MOUNTAIN HOME THEATRE

Finish Revisions 1/28/2026

Updated 06/30/2026

Bldg. 35

2 FIRST FLOOR FINISH PLAN
1/8" = 1'-0"

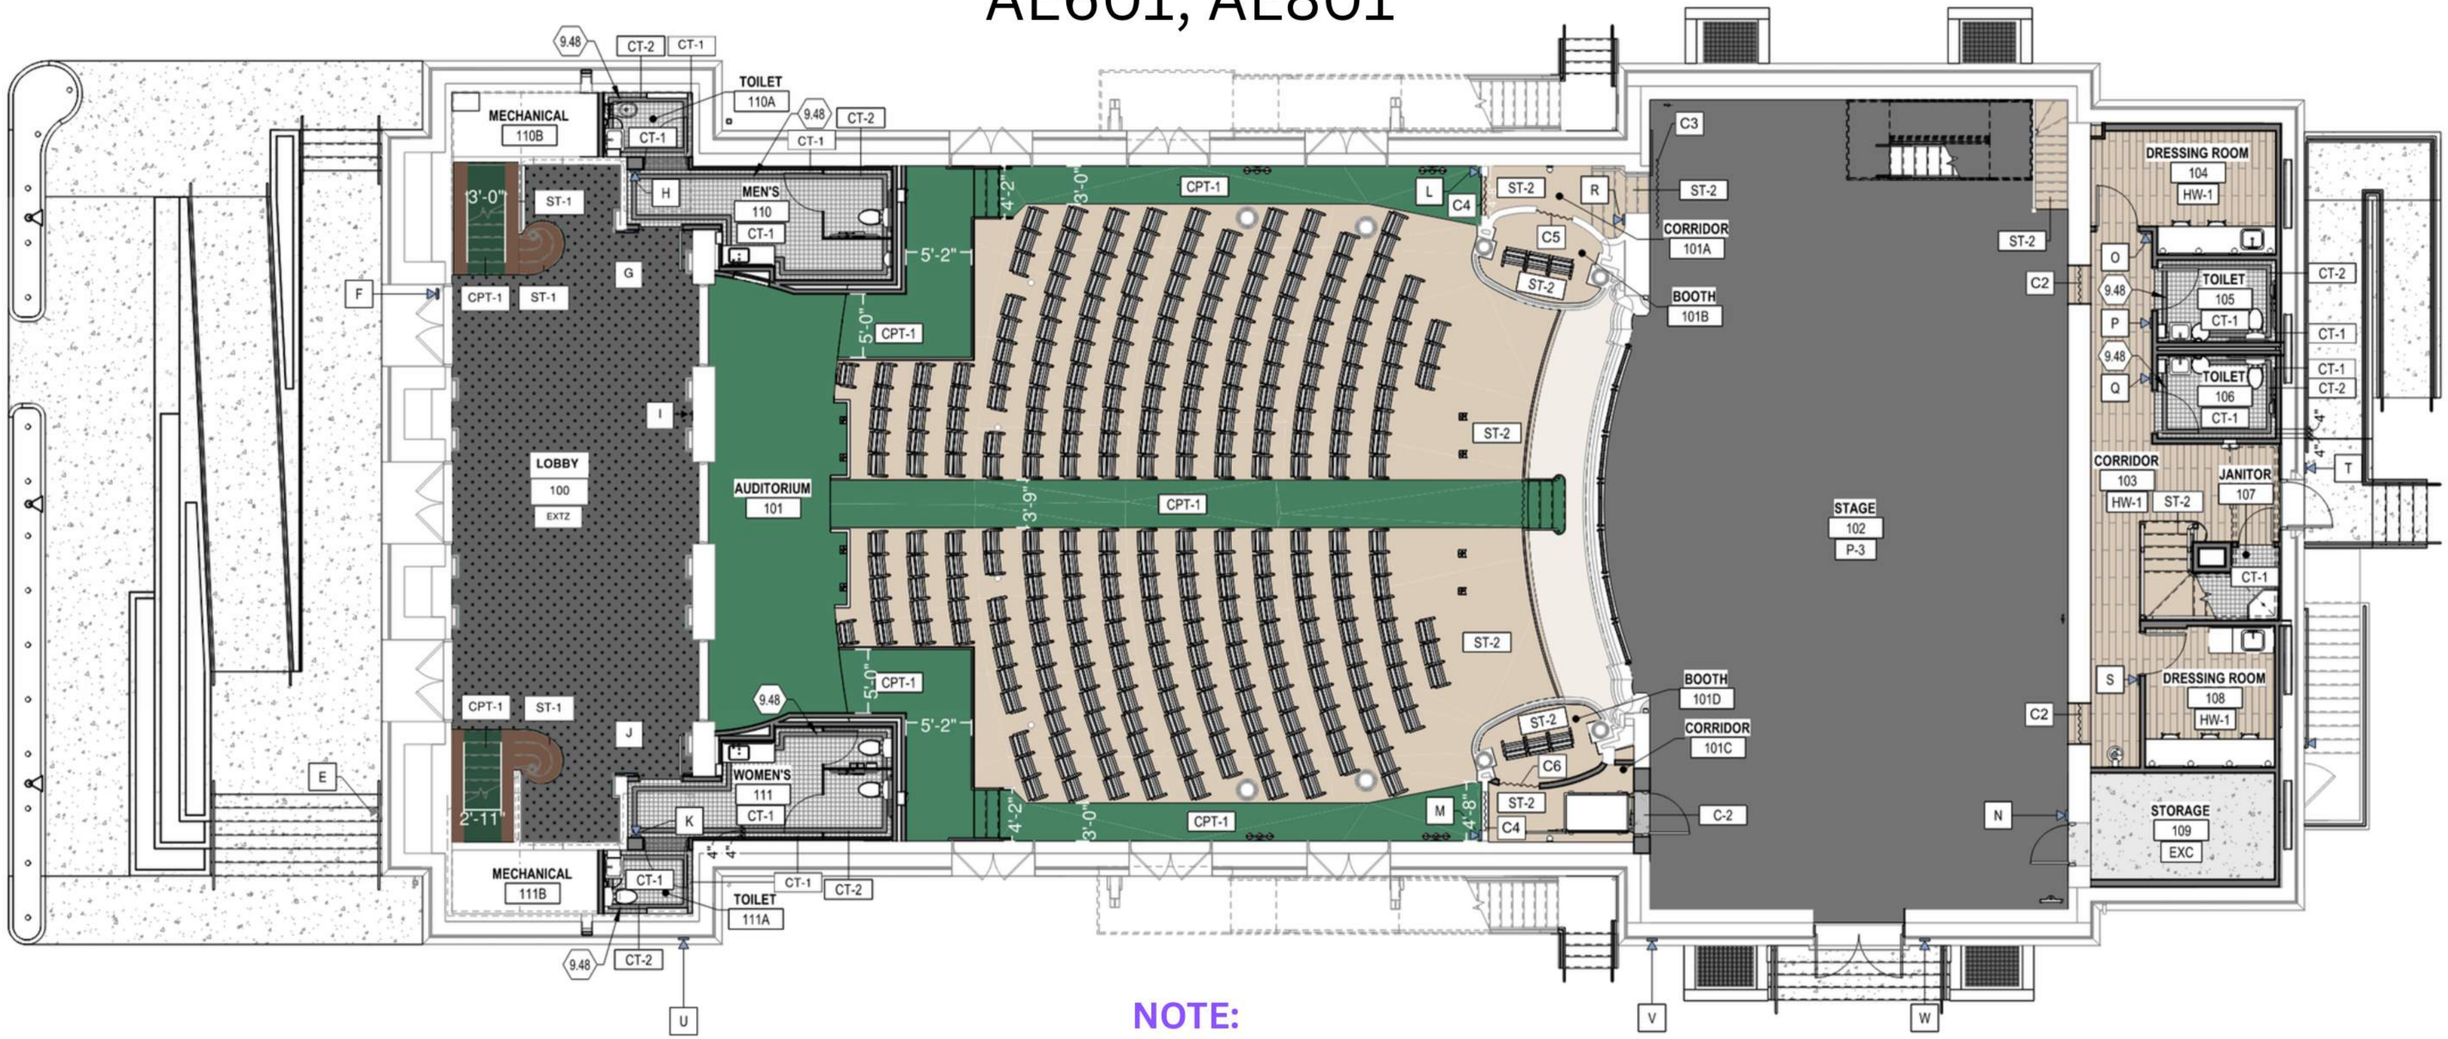
First Floor Finish Plan
AE601, AE801

Lobby 101: Remove Existing Carpet, Sand, Repair, and Refinish
Existing Hardwood and Existing Terrazzo.
No Stairs into Orchestra Pit
Install Carpet as Illustrated. All Exposed Edges to Have Serged Edge Binding w/Standard Non Skid Backing on Stairs w/Stair Rods

1 BALCONY, SECOND FLOOR, & CATWALK FINISH PLAN
1/8" = 1'-0"

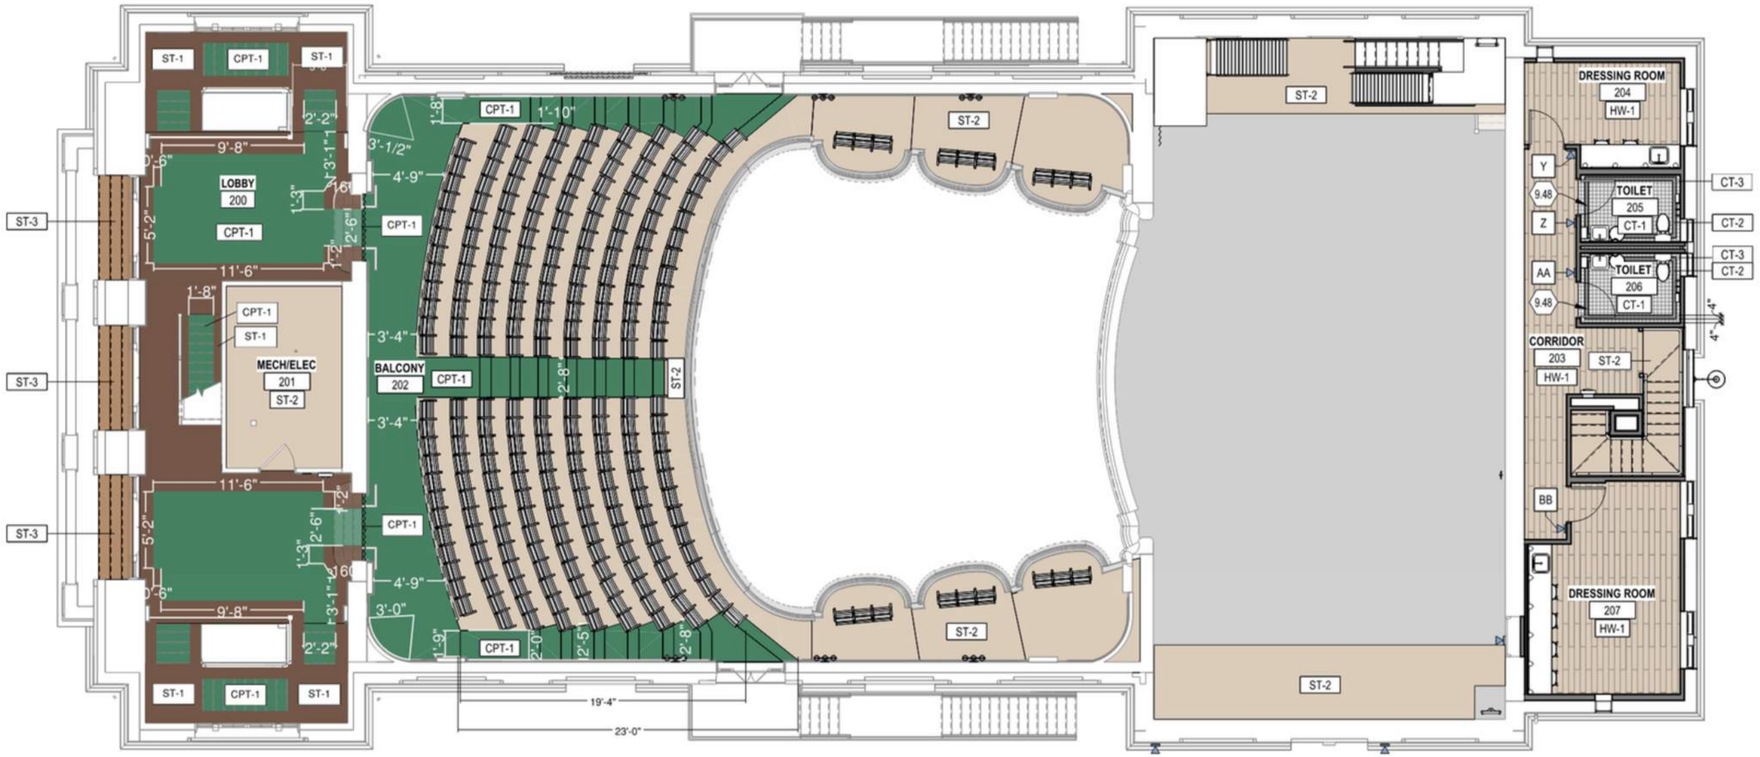
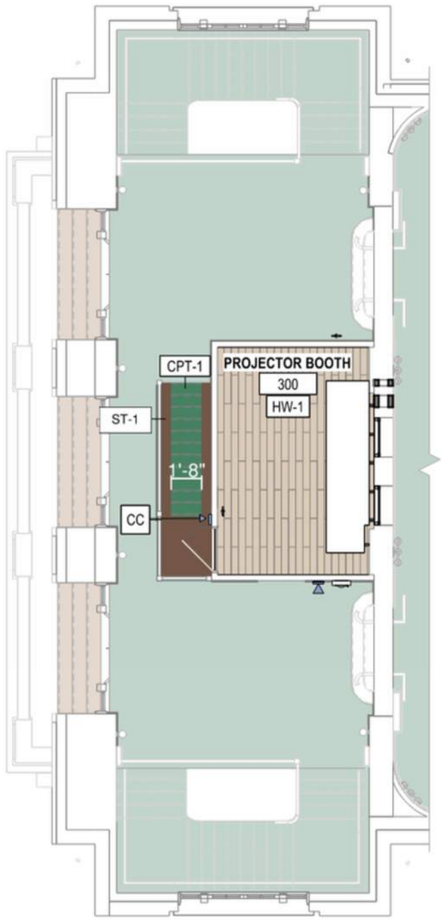
Balcony, Second Floor Finish Plan
REVISION_AE802

Lobby 200: Remove Existing Carpet, Sand, Repair, and Refinish Existing Hardwood.

Install Carpet as Illustrated. All Exposed Edges to Have Serged Edge Binding w/Standard Non Skid Backing on Stairs w/Stair Rods

RESTROOM FLOOR PLAN
REVISIONS TO AE601, AE801,

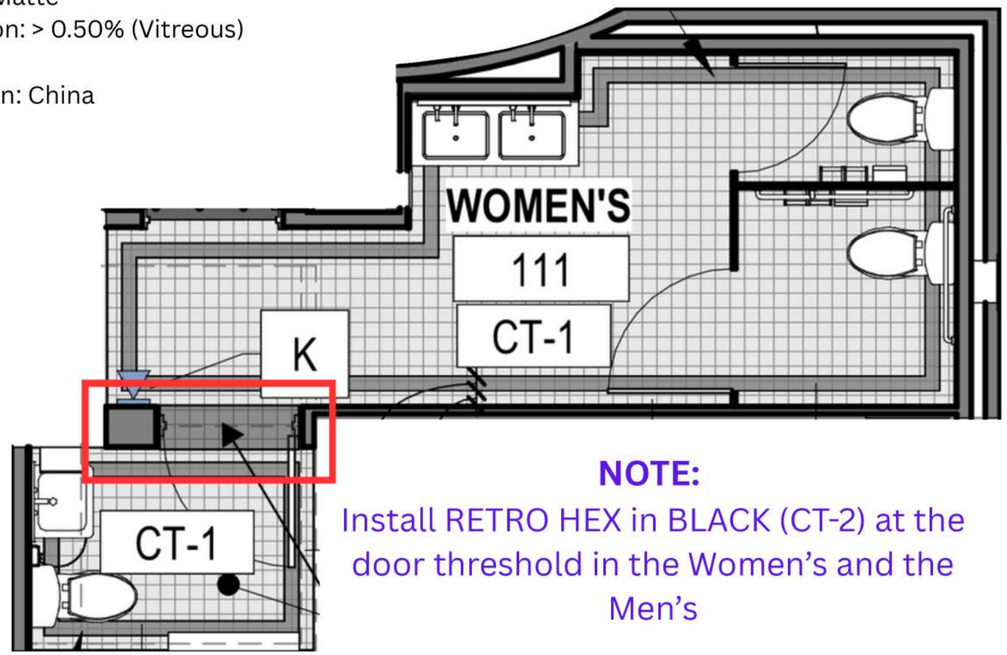
NOTE:
Install RETRO HEX in BLACK (CT-2) at the door threshold in the Women's and the Men's

RESTROOM INTERIOR ELEVATIONS
Revisions_AE601 & AE410

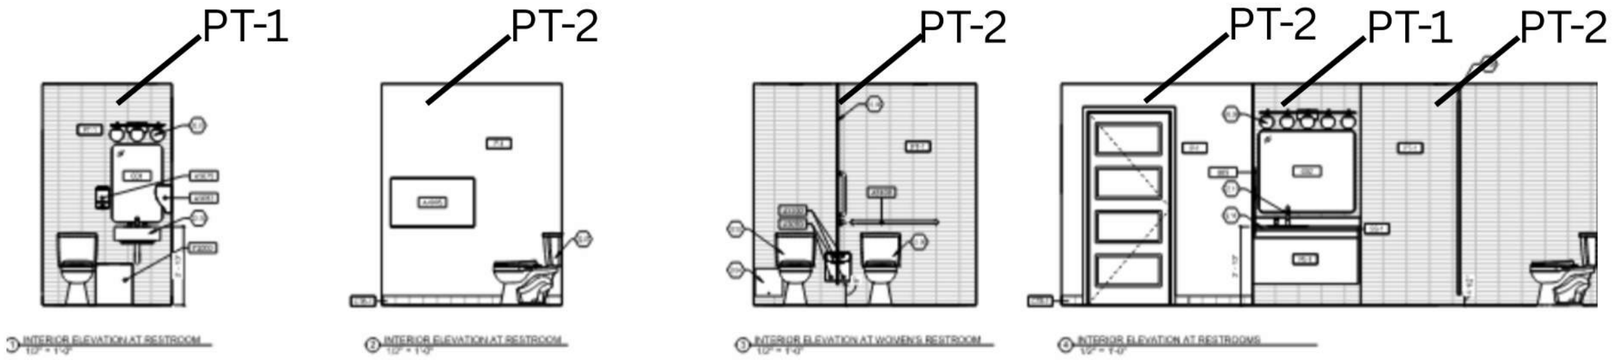
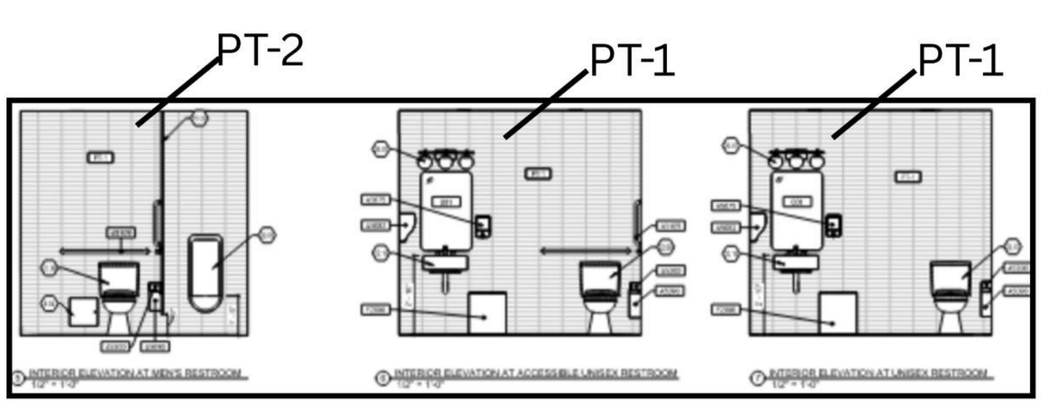
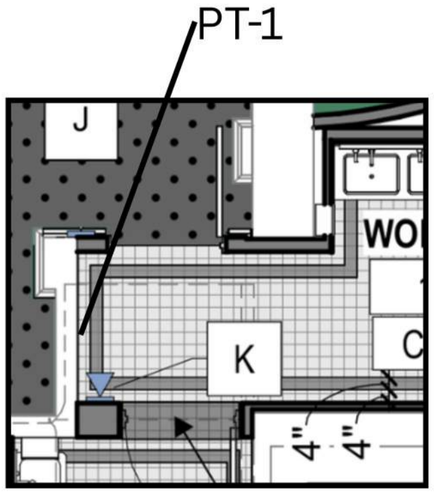
NOTE:

ADD WOOD CROWN TO MATCH EXISTING THEATRE CROWN
ALL SINK WALLS ARE PT-1, ALL OTHER WALLS PT-2

ST-1_Wood Stain

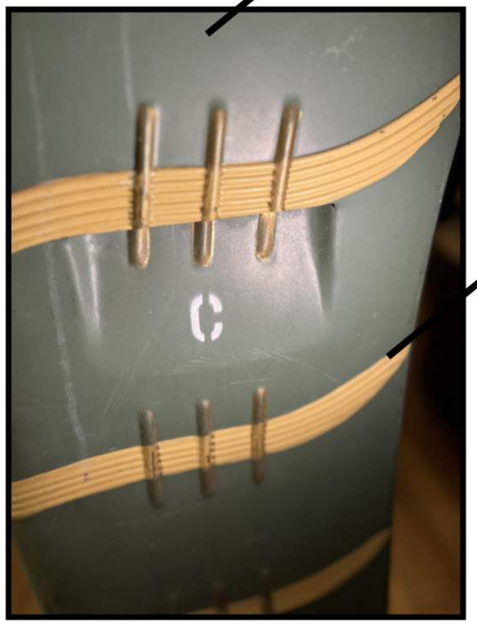
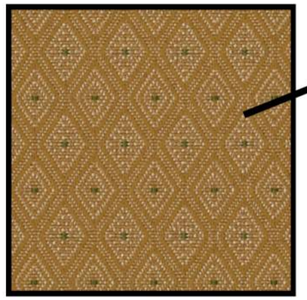
All Stains are to match existing
Arms of Auditorium are to match darker wall stain

Match Stain on arms of the chairs to the Wood Work on Box Seat

REMOVE STAIRS TO ORCHESTRA PIT

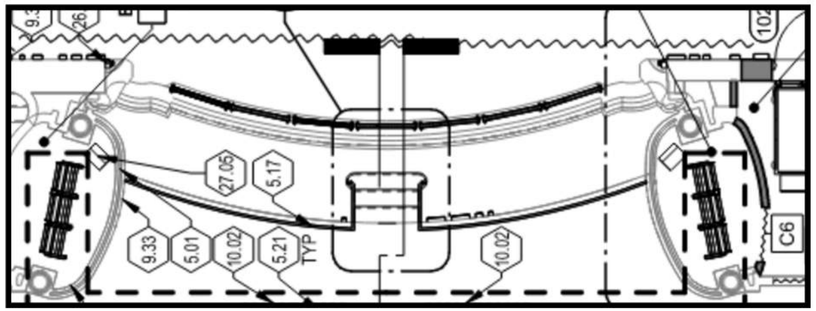
Orchestra pit railing_wood post, curtain and matching brass railing.

No stairs will be built from the auditorium to orchestra pit.
